RE: Petition under Clean Air Act §505 of Part 70 Air Quality Operating Permit Issued by North Carolina Department of Environment and Natural Resources Duke Energy Progress - Richmond County Combustion Turbine Facility Hamlet, NC, Richmond County Facility ID: 7700070, Permit No. 08759T17

RE: Duke Energy Progress - Richmond County Turbines, Richmond County Energy Complex Application ID: 7700070.11A, Permit No.: 08759T15

On behalf of the Blue Ridge Environmental Defense League, I write to provide comments on the Richmond County Turbines draft permit.

June 16, 2014, Hamlet, NC, Photo by Kim McCall

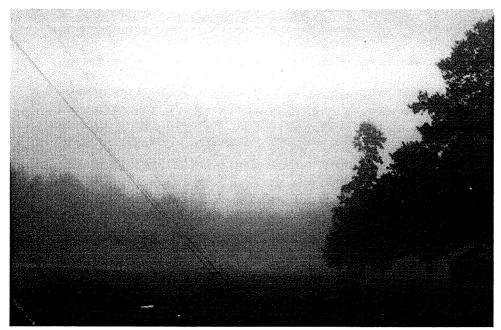
The evidence we have compiled shows that the Richmond County turbine plant is not in compliance with air quality standards. The photographs taken of dense smoke and the complaints made to officials by Richmond County residents indicate that the plant is in violation of the limit on opacity and particulates. Particulate matter can be emitted from the smoke stack or formed in the atmosphere when gaseous pollutants such as SO₂ and

The photograph illustrates the problem. Residents of the Waymon Chapel Road community next to the turbine facility took photos near the plant in summer and winter, pointing to illegal emissions of thick smoke, accompanied by a metal taste and a burning smell.
